<b>marantz®</b> <b>SERVICE BULLETIN</b>		Date: 15-May-2003	Model SR7300
		Page: 1/1	REF.NBR: MZ03-003
Circulation:		Subject:	
Application:		Broken Knob	
x for information customer complaint in case of service mandatory .....		Int.ref:	
MZxxxxx01xxxx to MZxxxxx13xxxx

<b>marantz®</b> <b>SERVICE BULLETIN</b>		Date: 15-May-2003	Model SR7300
		Page: 1/2	REF.NBR: MZ03-006
Circulation:		Subject:	
Application:		Improvement of high tone noise	
x for information customer complaint in case of service mandatory .....		Int.ref:	
ALL

<b>marantz®</b> <b>SERVICE BULLETIN</b>		Date: 15-May.-2003	Model: SR7300,SR6300
		Page: 1 / 1	REF.NBR: MZ03-018
Circulation:		Application:	
x for information customer complaint in case of service mandatory .....		See Below	
		Subject: The problem that the remote controller can't lean other the remote controller .	
		Int.ref:

<b>marantz®</b> <b>SERVICE BULLETIN</b>		Date: 10-July-2003	Model: SR7300.SR7300F
		Page: 1 / 1	REF.NBR: MZ03-030
Circulation:		Subject:	
Application:		RS232C control is changed to “ new protocol ”.	
x for information customer complaint in case of service mandatory .....		Int.ref:	
		MZxxxxxx01xxxx to MZxxxxxx16xxxx

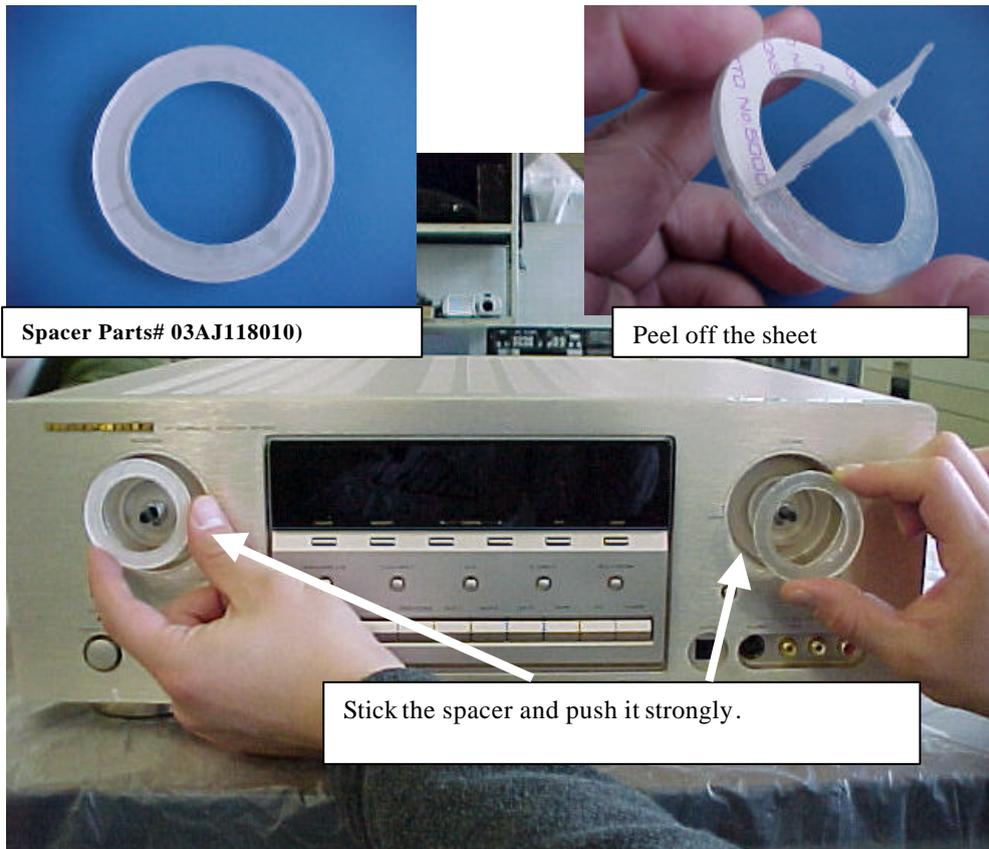
Broken Volume or Selector knob by transportation.

A clearance between the front panel and knob were a little large and get stress to the volume shaft.

Add the spacer to the front panel as follows.  
( Spacer : parts No. 03AJ118010)

Peel off the sheet

Stick the spacer and push it strongly.

**Solution 1** ( For lot 01 to 15)

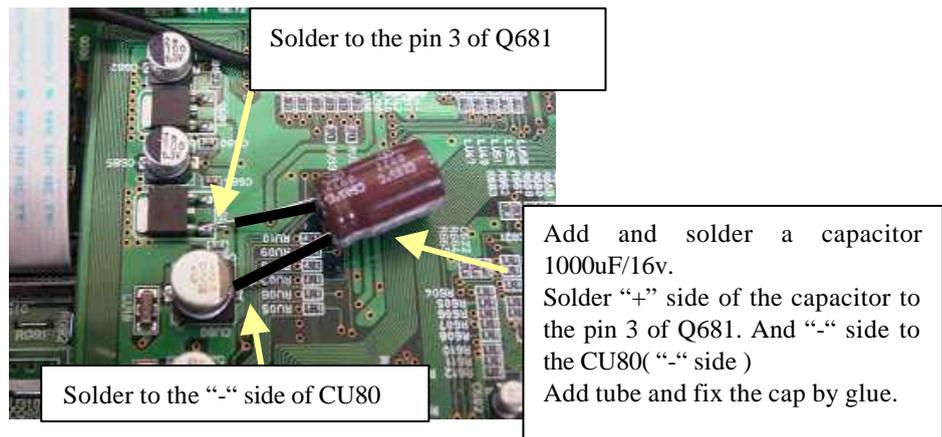
High tone noise can be heard a little from speaker.

- 1) Cut a jumper wire [U304] on the PS04 board.

- 2) Add a capacitor < 1000uF/10V : Parts # OA10801020> between the pin 3 of the Q681 and the “-“side of the CU80 as follows.

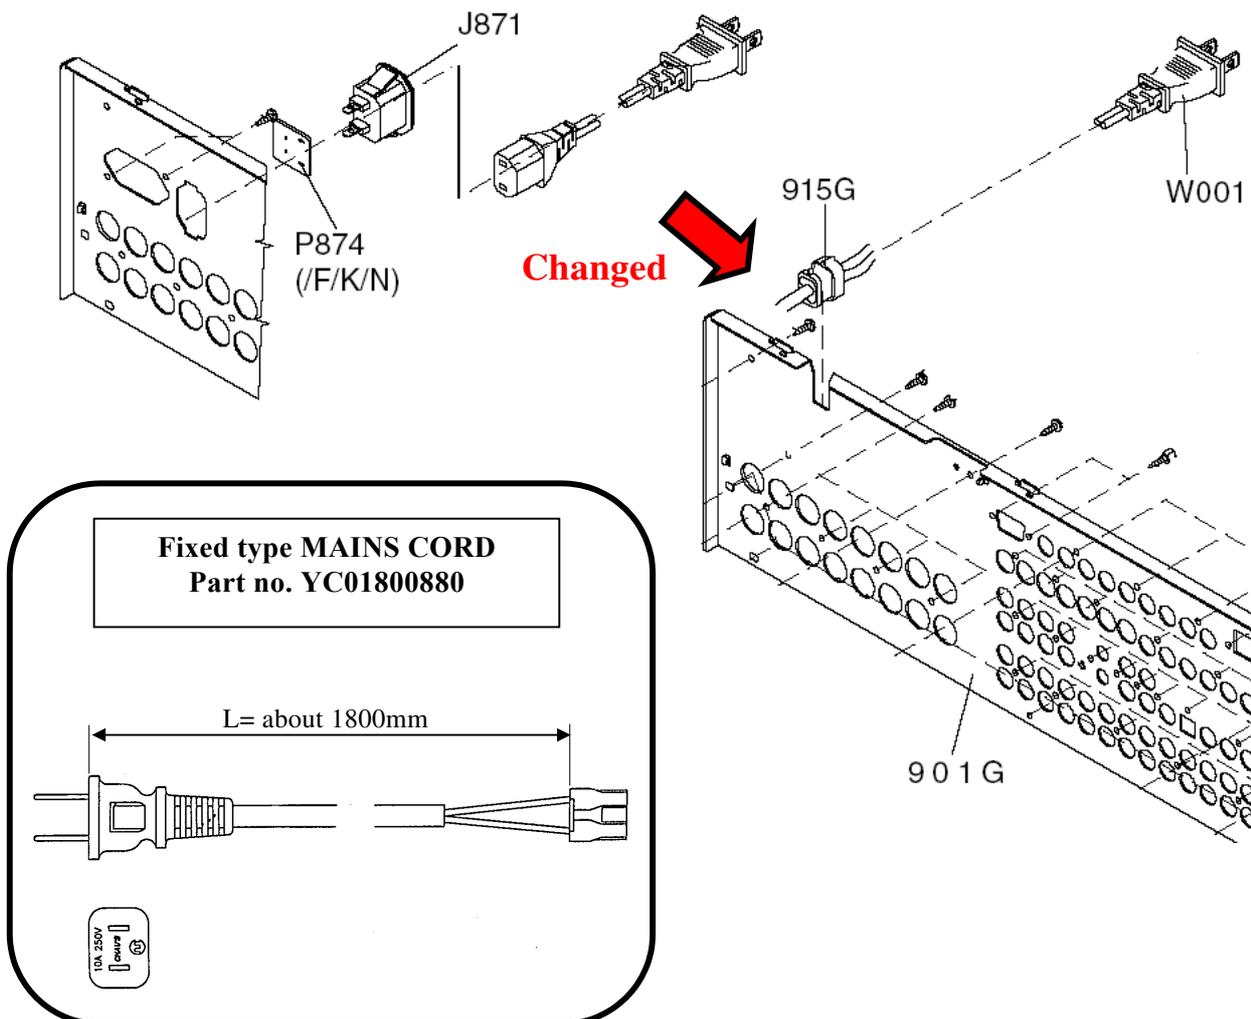
It depends on the Chinese safety standard requirement.

1. MAINS CORD is changed from (Z011) part no. ZC01803090 to (W001) part no. YC01800880 .
2. MAINS CORD BUSH ( 915G ) part no. 450H259010 ( NIFCO #2271) is added.
3. REAR PANEL ( 901G ) is changed.(This is not supply of the service spare part)
4. AC IN socket is deleted.
